METROPOLITAN GOVERNMENT OF NASHVILLE AND DAVIDSON COUNTY

STAFF RECOMMENDATION
1814 Boscobel Street
June 19, 2013

Application: New construction—Infill
District: Lockeland Springs-East End Neighborhood Conservation Zoning Overlay
Council District: 06
Map and Parcel Number: 08314032700
Applicant: William Wood, Synergy Development Group
Project Lead: Melissa Baldock, melissa.baldock@nashville.gov

Right Side Elevation

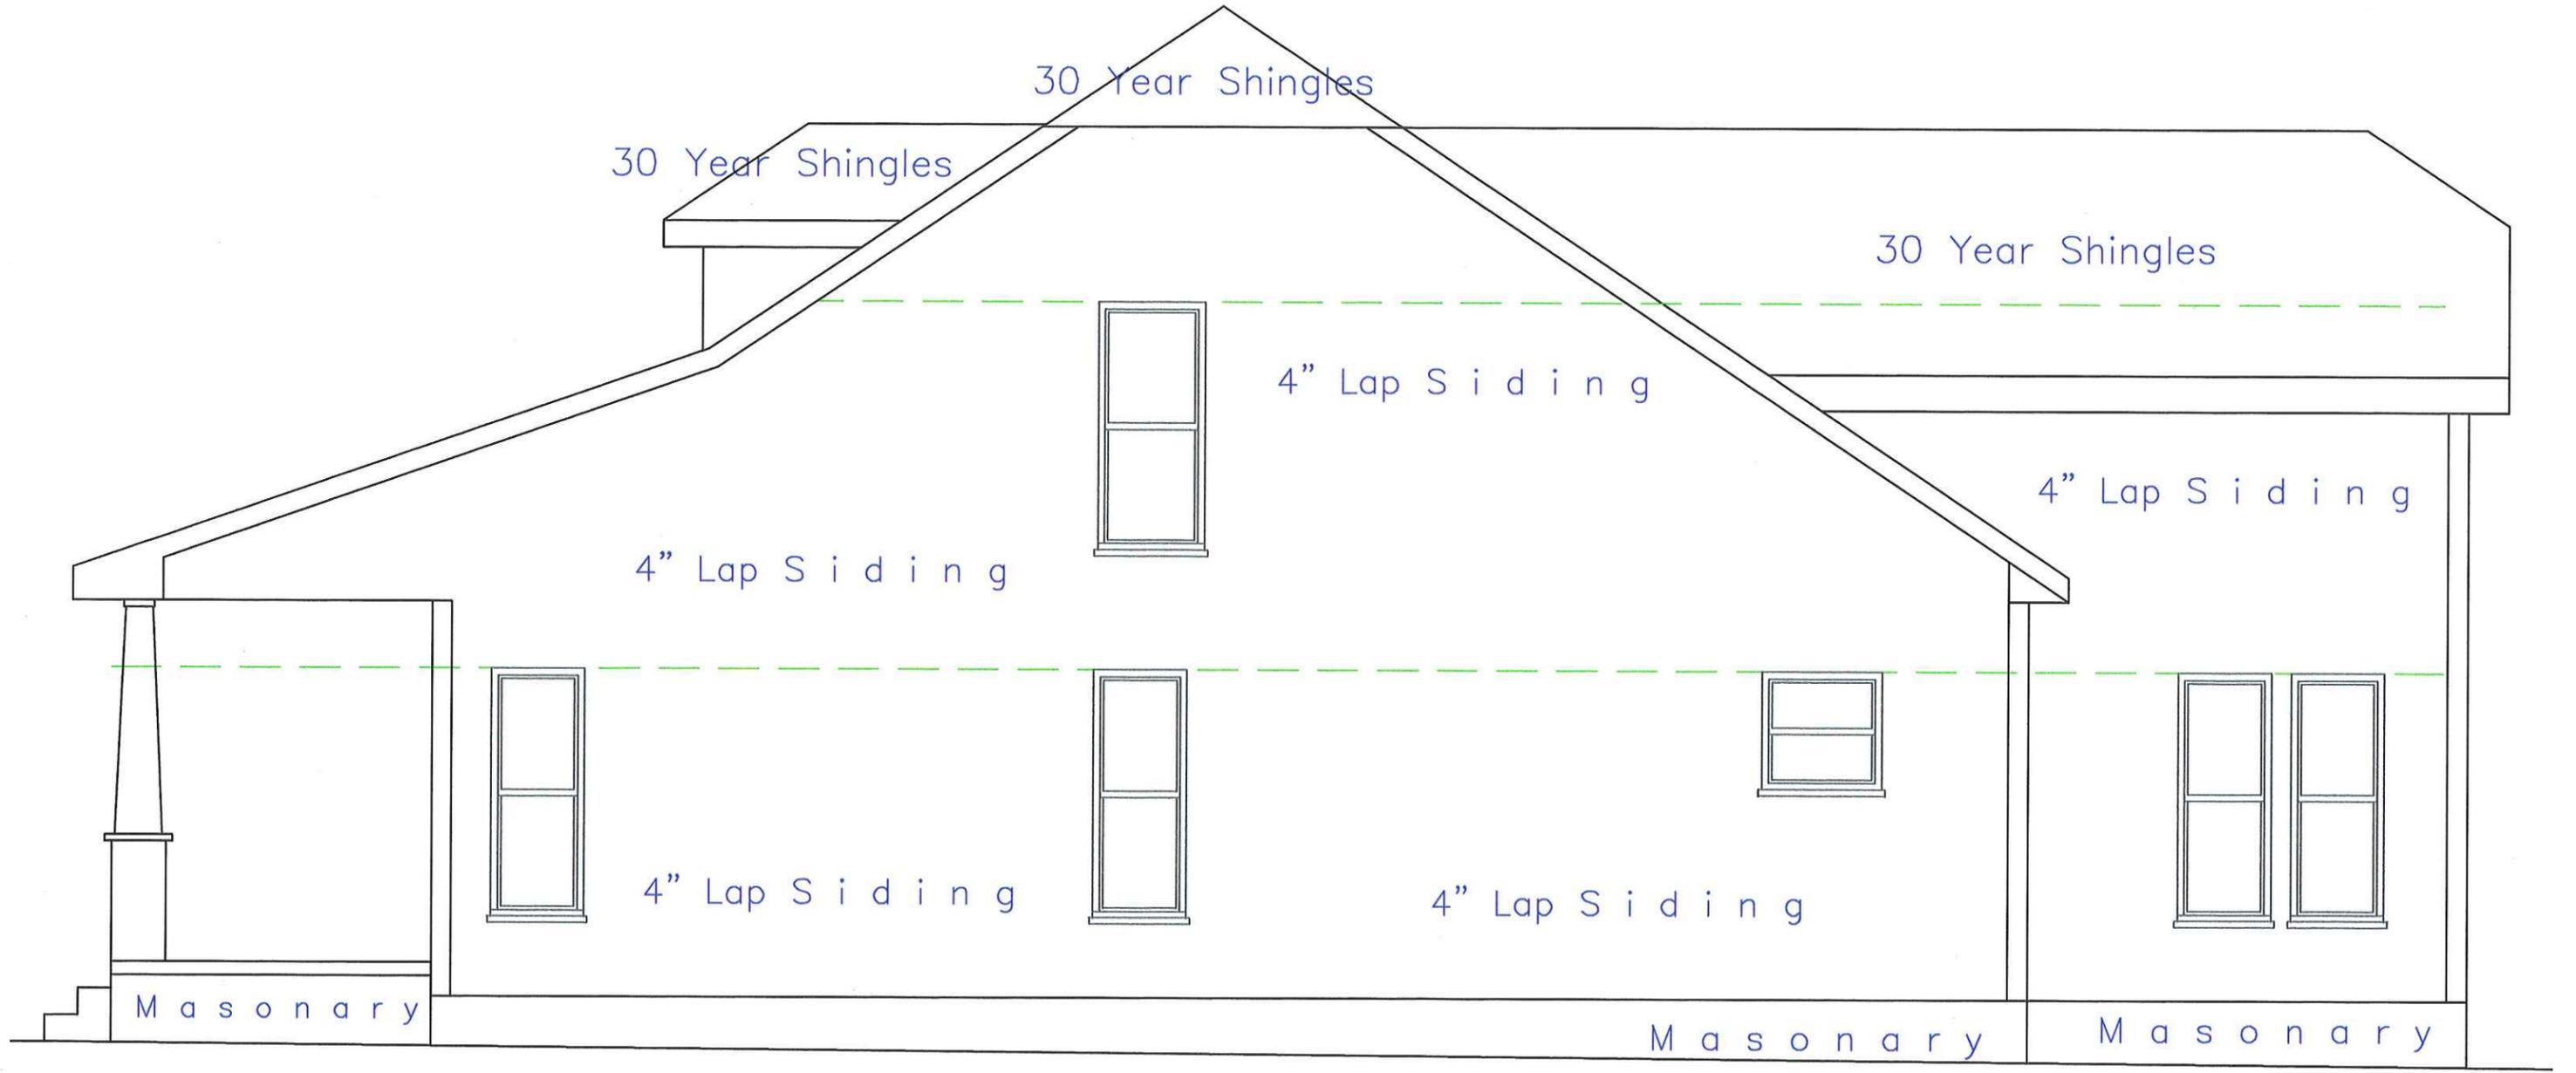
Staff notes that the drawings do not show a door frame around the front door, and asks that one be included. Likewise, the double windows on the front, rear, and right side elevations should have a frame around the pairs and a four to six inch (4"-6") mullion in between the windows. Staff also suggests that adding a band board on the side façades at the change in floor level will help break up the façade. Finally, staff asks that the front porch columns have a more substantial cap.
